Amendment 108 to Local Planning Scheme No. 3 - Proposed Rezoning of Lot 32 (4) Kirkdale Road and Lot 33 (4) Orange Valley Road, Kalamunda

SUBMISSION TABLE

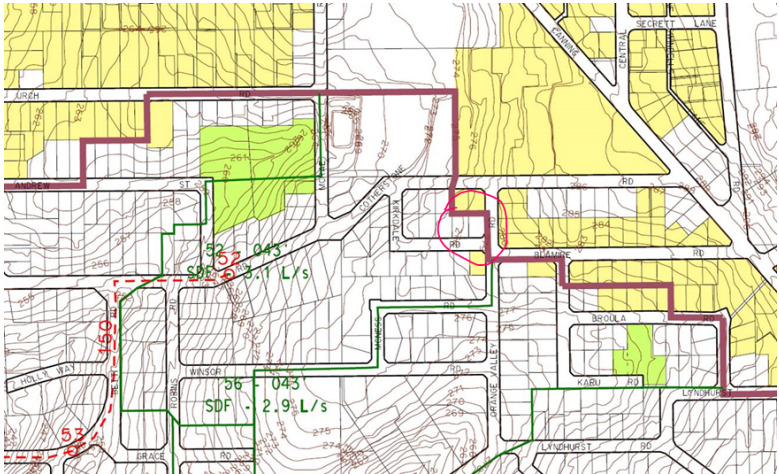
<p>and sewer grades, the Corporation would consider taking a small amount of flow into the network.</p> <p>Any approved extensions of the Water Corporation reticulation network would be customer funded.</p>  <p>The map displays a topographic area with contour lines and a proposed sewer reticulation network. Key features include:         <ul style="list-style-type: none"> <li>Flow rates: 0.43 L/s, 2.9 L/s, and 5.3 L/s.</li> <li>Street names: SECRETY LANE, CENTINA, WANSOR, GRACE, LYNDHURST, KABU, BROULA, and LYNDHURST RD.</li> <li>Flow direction: Indicated by arrows along the sewer lines.</li> <li>Topographic contours: Shown in brown, indicating elevation changes.</li> </ul> </p>	<p>The consulting engineer drawings were included in the attachments of the council report to initiate advertising. Following further correspondence, it is understood, more detailed designs at the subdivision/ development stage would be required to determine if the proposed concept design would be adequate. It is noted a small amount of flow into the network maybe supported.</p>
